Montgomery Bicycle Advocates
7121 Thomas Branch Dr.
Bethesda, Md. 20817

March 9, 2009

Re: Please do not reject ICC Trail "Option 3" in Rock Creek area

Figure 4 Needwood Road Options

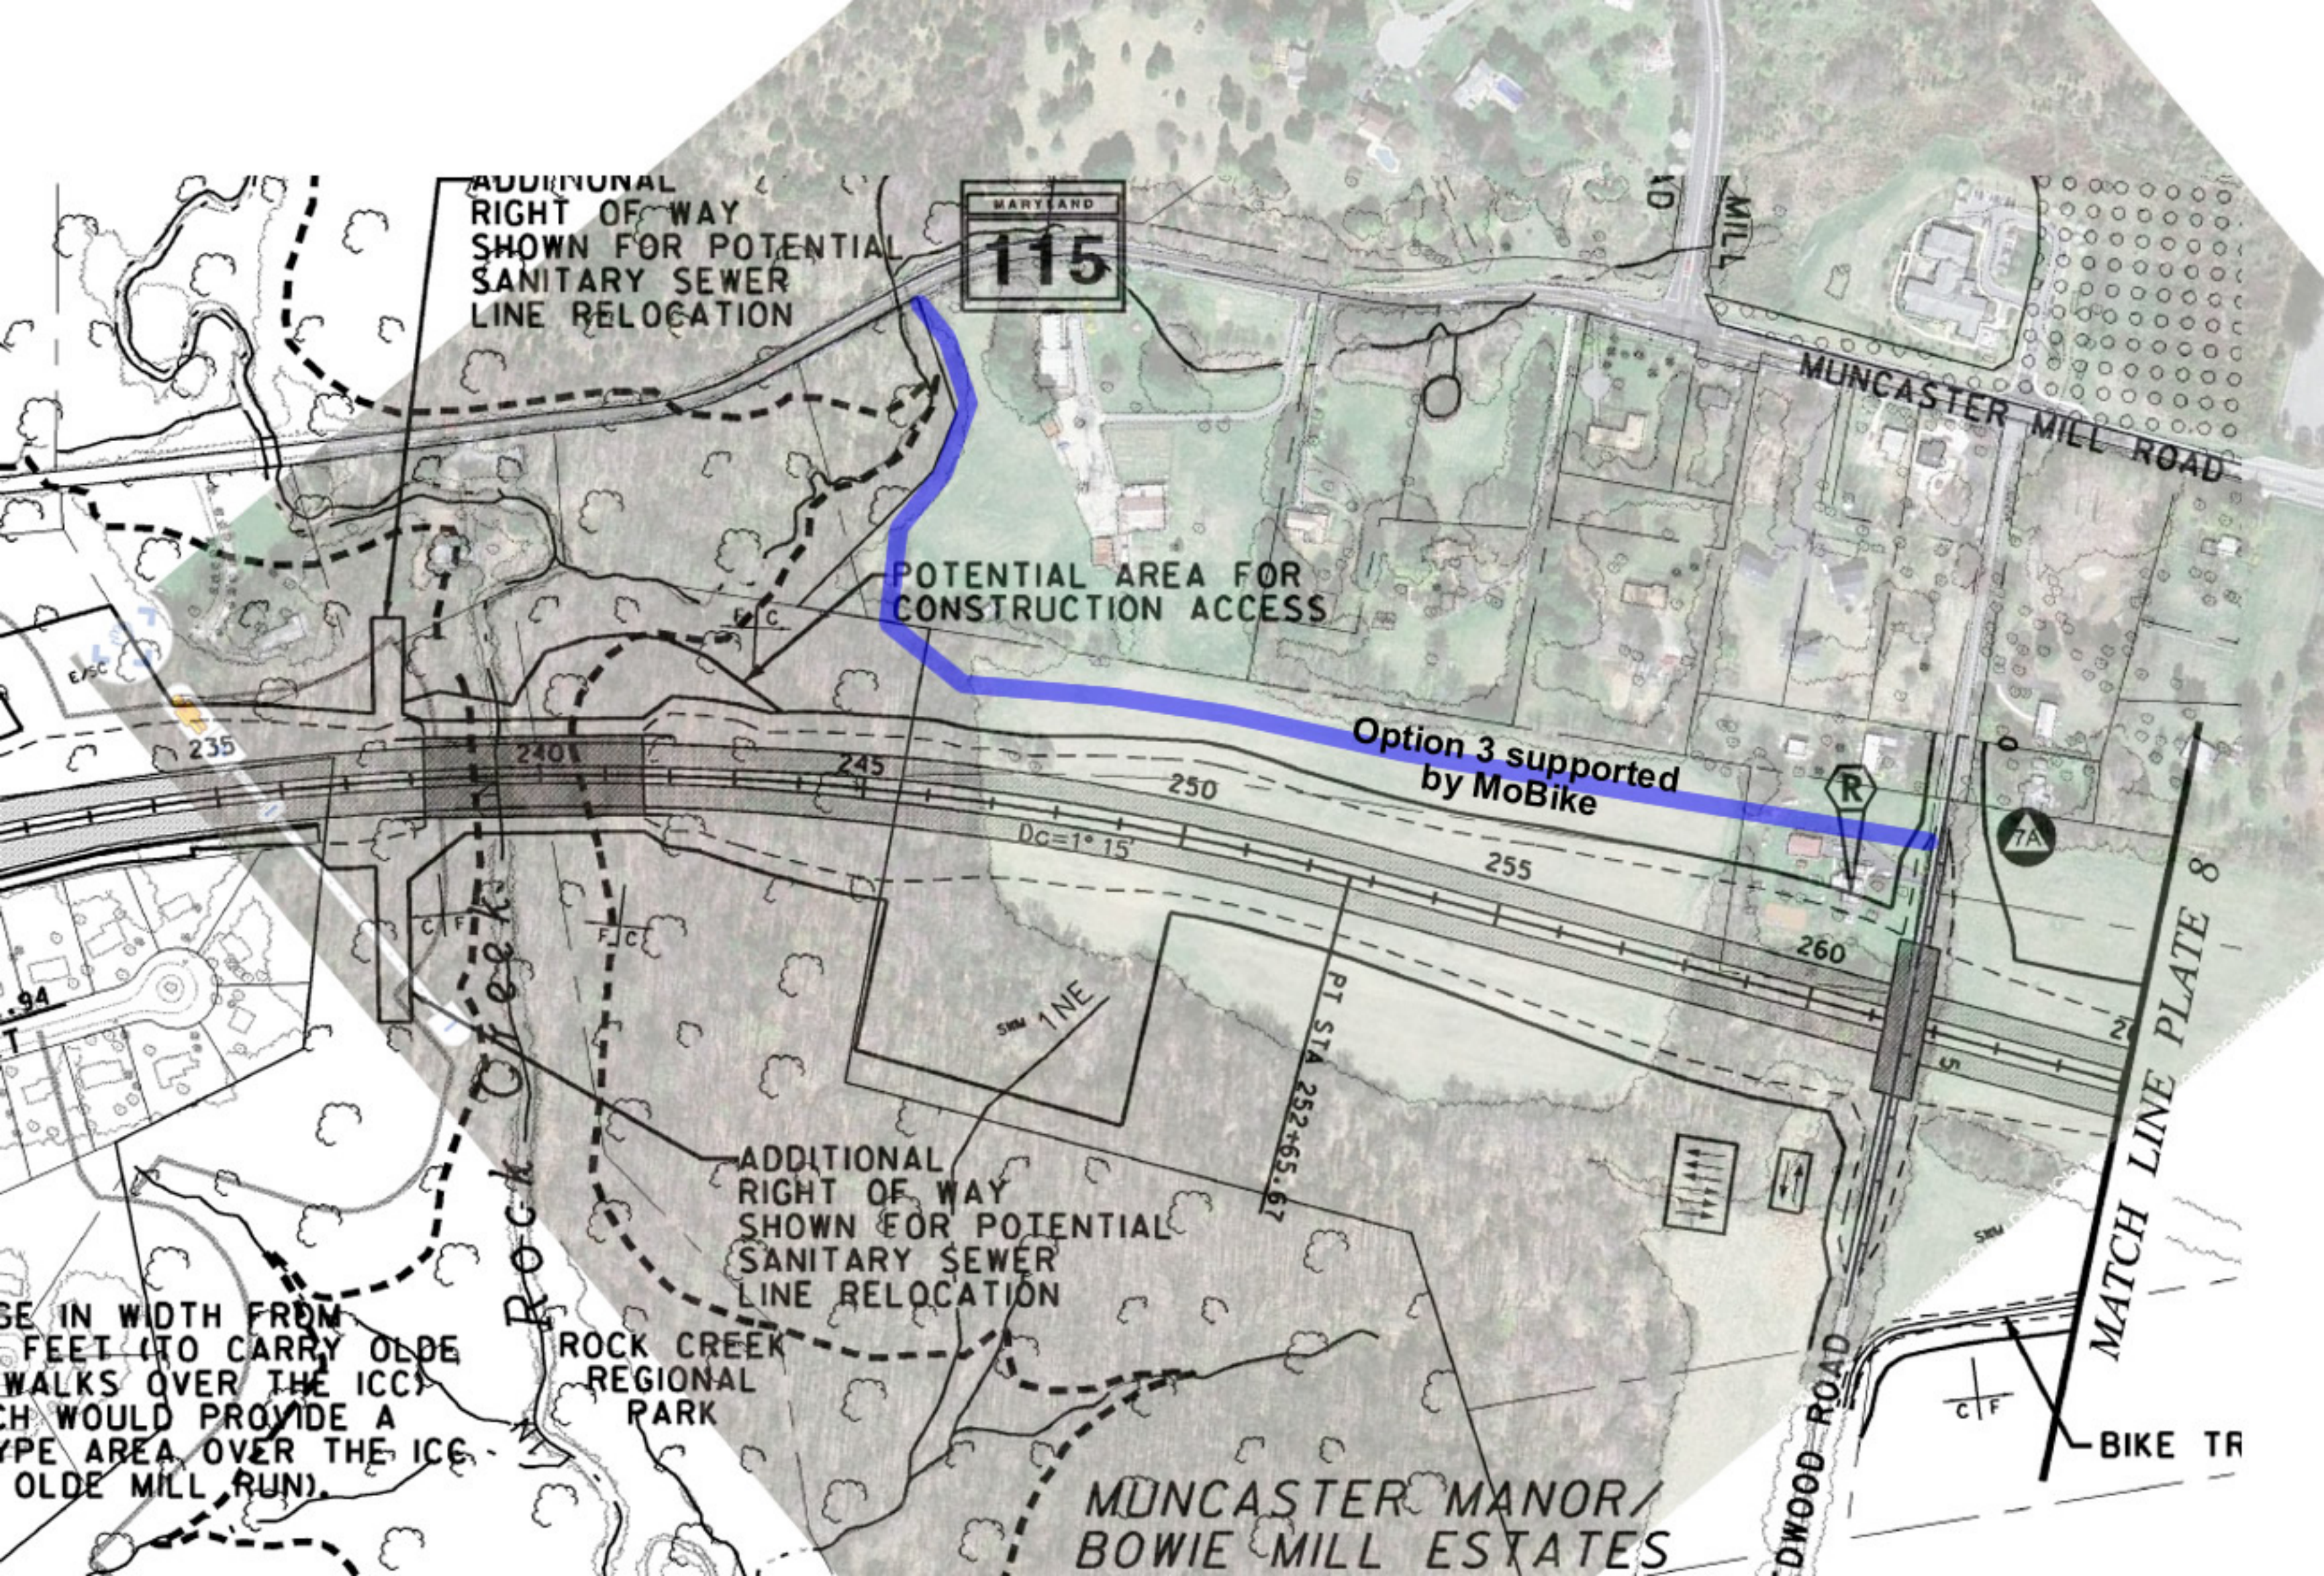
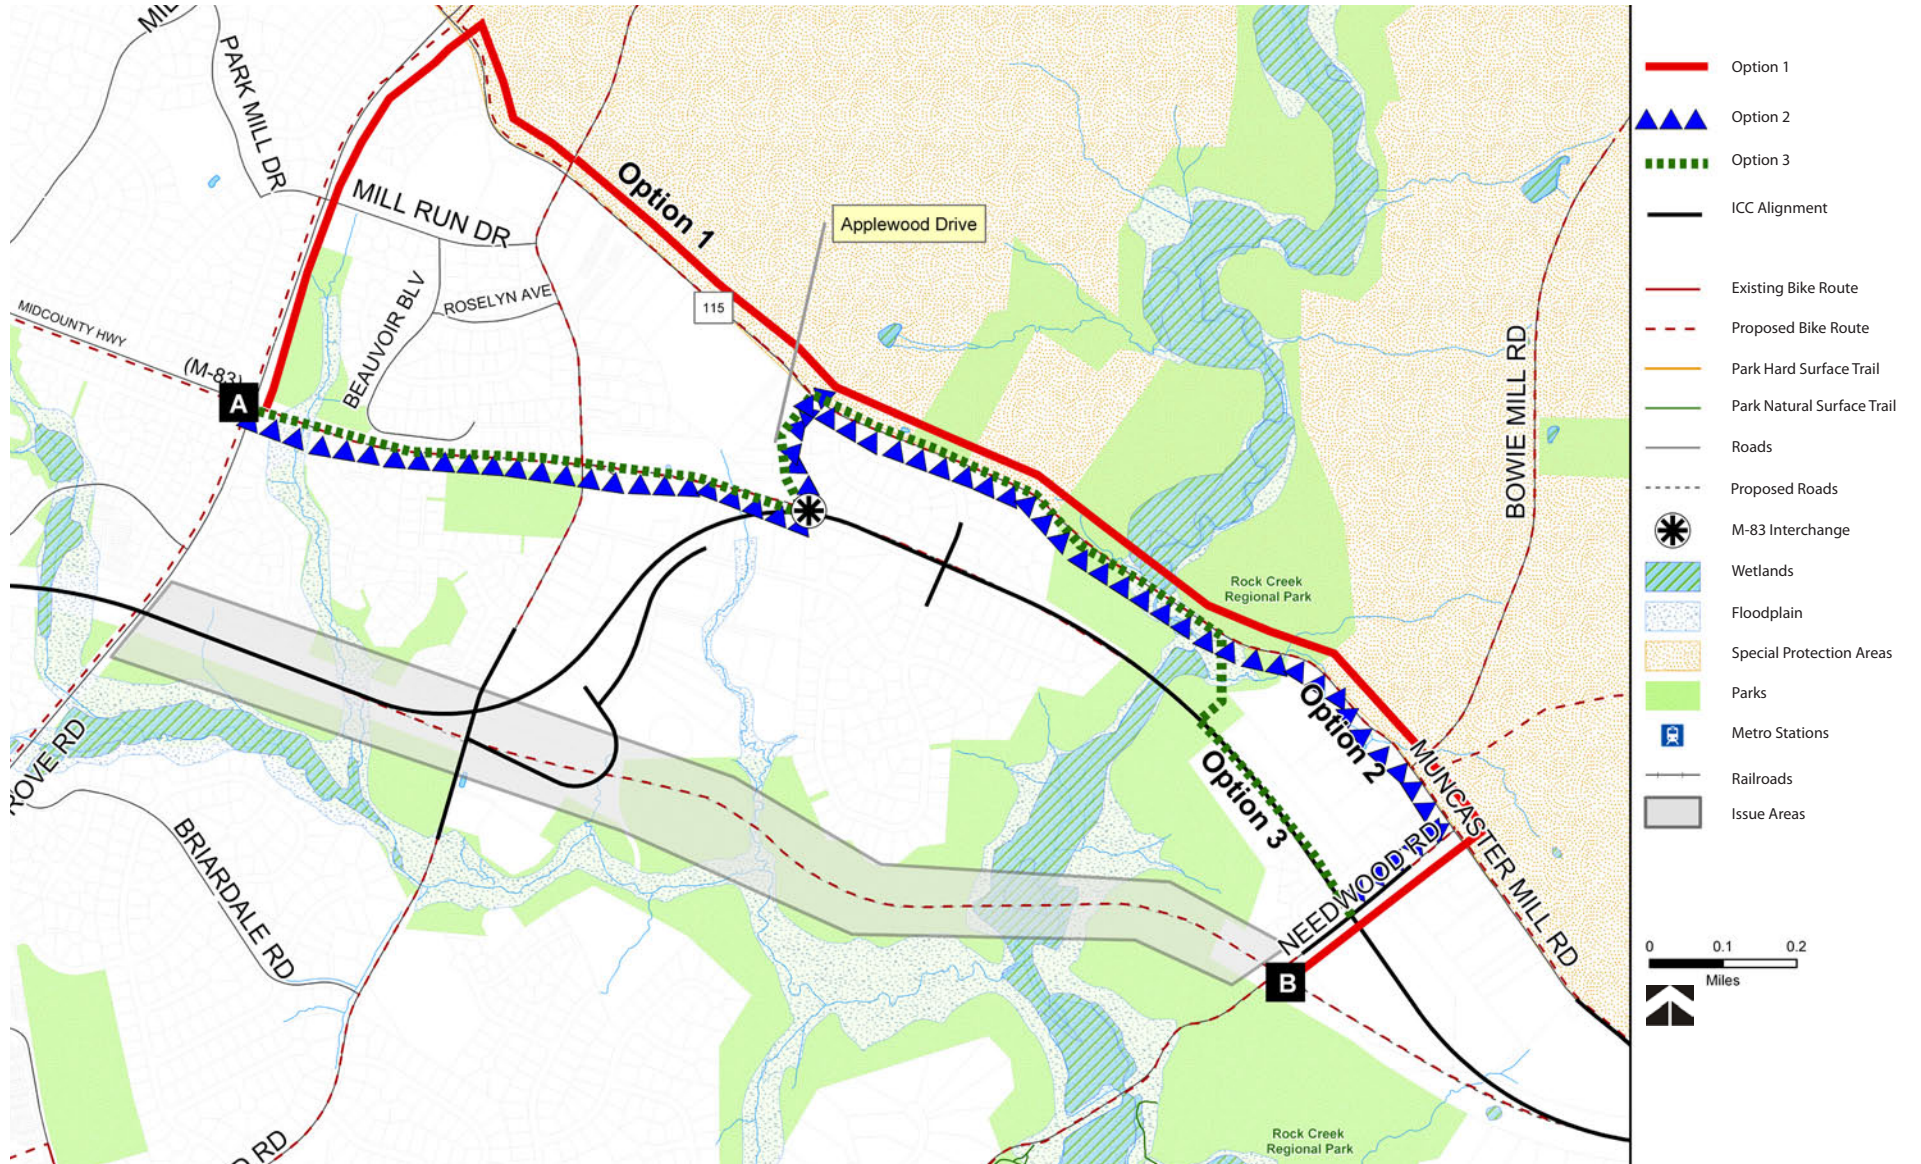
So pardon our persistence if we are still concerned about the section of trail along Muncaster Mill Road west of Needwood Road. Trail supporters have compromised to accept a general alignment along Muncaster Mill Road, but we can imagine no reason for M-NCPPC's rejection of the highly superior option in that corridor, called "Option 3" in the Master Plan Amendment (as depicted in the attached M-NCPPC diagram). The Council appears to be heading towards putting only Option 2 in the master plan. M-NCPPC's rationale for rejecting Option 3 is that it "connects through the park (and through wetland or along steep slopes)".

This is simply wrong. Option 3 doesn't go through these sensitive areas unless one tries very hard to pick the worst possible alignment. **Option 3 stays out of forest and flood plan (let alone wetlands) and is set almost entirely in a vacant strip of land sandwiched between the highway and backyards, maybe 200' wide.** Literally it's a field left vacant for construction of the ICC. The last leg of Option 3 turns north before it would otherwise have to enter the park, thus sparing parkland to be graced only by the gentle touch of the six-lane ICC highway. **This final 500' leg avoids forest and flood plain and could be built to skirt the park,** along the boundary between the park and the large institutional lawn next to the park – even on the private side if arrangements could be made.

Option 3 is strongly preferred because it would avoid a number of driveway crossings and a signalized intersection. Driveway and street crossings have been cited by trail supporters as the number one problem with the state's many ICC trail detours.

So please do not reject Option 3 until you have had the chance to look closely into its environmental impacts. One solution is to phrase the master plan amendment in a way that does not explicitly choose between Option 2 and Option 3 in this area, but makes it possible to implement either or both options after due analysis.

Option 3 supported
by MoBike
